# Rezoning Transportation Analysis

Petition Number: 2019-062

## Revision Log:

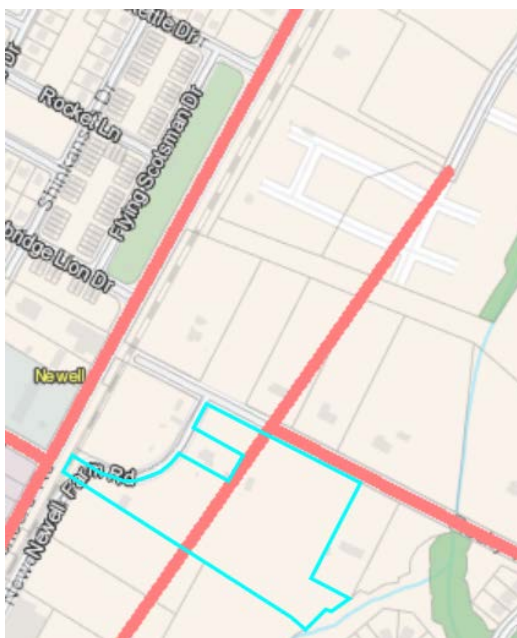
1. **Curbline** The proposed zoning district has a setback measured from back of the existing or proposed future curblines. The location of the future back of curb is 26' from centerline along Rocky River Road to account for minor thoroughfare with buffered bike lane to point shown below (Approximate location, CDOT can work with petitioner with where the intersection will occur). After that point the future back of curb is 13' from center line in accordance to CLDS U-02. Per chapter 19 the developer should install curb and gutter as part of this development.

- a. **New Comment based on revised site plan 8/12/2019:** The petitioner should revise the site plan to include a typical for Rocky River Road.
  - b. **New comment based on revised site plan 8/12/2019:** The petitioner should revise the site plan to clearly dimension the curb and gutter from the centerline of the road.

- c. **New comment based on revised site plan 8/12/2019:** The petitioner should revise the site plan to clearly show curb and gutter along Rocky River Road.

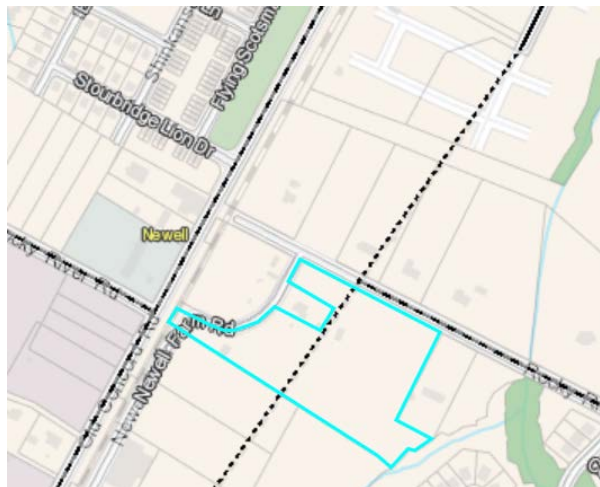
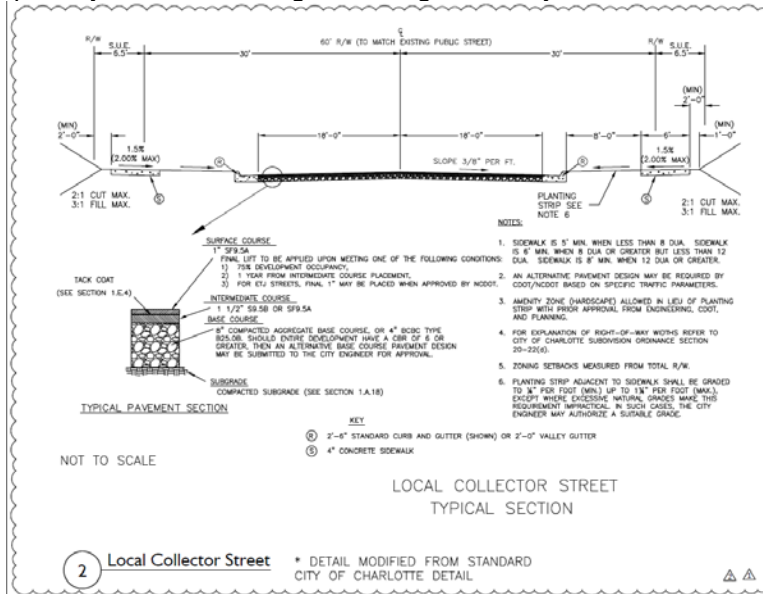
2. **Traffic Study** A Traffic Impact Study is not necessary for the complete review of this petition.
3. The petitioner should revise the site plan and conditional note(s) to commit to constructing a public road to meet the intent of the Minor Thoroughfare road right-of-way through the site as prescribed by the Comprehensive Transportation Plan approved by the Charlotte Regional Transportation Planning Organization. The cross-section should match what was previously approved by development north of site as shown below.

- a. **New comment based on revised site plan 8/12/2019:** The 36' of pavement will be used for future travel lanes. The petitioner should revise the site plan due to proposed on-street parking on University East Extension based on the following options:

- i. Place on-street parking outside of the 36'.
    - ii. Remove bulb-outs at intersections to allow future travel lanes. This would allow on-street parking on the road, but it can't count as required site parking. In addition, note C3 should remove, "on-street parking shall be allowed on the University East Collector Road."

- b. **New Comment based on revised site plan 8/12/2019:** The petitioner should revise the site plan to include a typical for University East Extension.
- c. **New comment based on revised site plan 8/12/2019:** The petitioner should revise the site plan to clearly dimension the curb and gutter from the centerline of the road.
- d. **New comment based on revised site plan 8/12/2019:** The petitioner should revise the site plan to graphically show curb and gutter along University East Extension.
